ARKLOW HARBOUR.

ARKLOW HARBOUR.

SKETCH PLAN ACCOMPANYING REPORT OF THIS DATE 8TH JAN^Y. 1886.

SHOWING PROPOSED ALTERATION TO PIERHEAD.

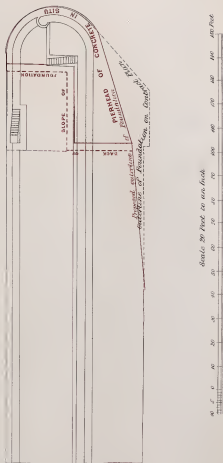
As regards the manner of completing the pier, and the construction of the pierhead, we find from borings which we have had made, that at the pierhead the sea-bed for a depth of nine feet, consists of sand and gravel, the lower portion, for four to five feet in thickness, being of compact gravel; immediately under this bed of gravel there is a depth of fourteen feet of soft muddy sand, and under this there is strong boulder clay, the upper surface of which being thirty-seven to thirty-eight feet under the level of low-water. The clay would afford a quite satisfactory foundation, but the great depth would involve a very large expenditure, and we have, therefore, to recommend that the foundations of the pierhead should stop at the top gravel bed, or about twenty-one to twenty-two feet under low water, and that from that level the pier should be carried up of solid concrete.

We have further to recommend that the quay wall adjoining the pierhead should be carried to the same depth for the distance landwards shown in blue lines on the sketch, or such other distance as, in the opinion of the Chief Engineer, may be deemed necessary. For the sake of simplifying the execution of this solid pierhead, the blocks already made for the sixty feet or so of the sea wall next the pierhead should be slightly reduced in breadth on their lower beds, and the lower block set by so much inwards, so as to gradually bring the present face slope of 1 to 1 to about $\frac{1}{2}$ to 1 at the point where the solid wall begins.
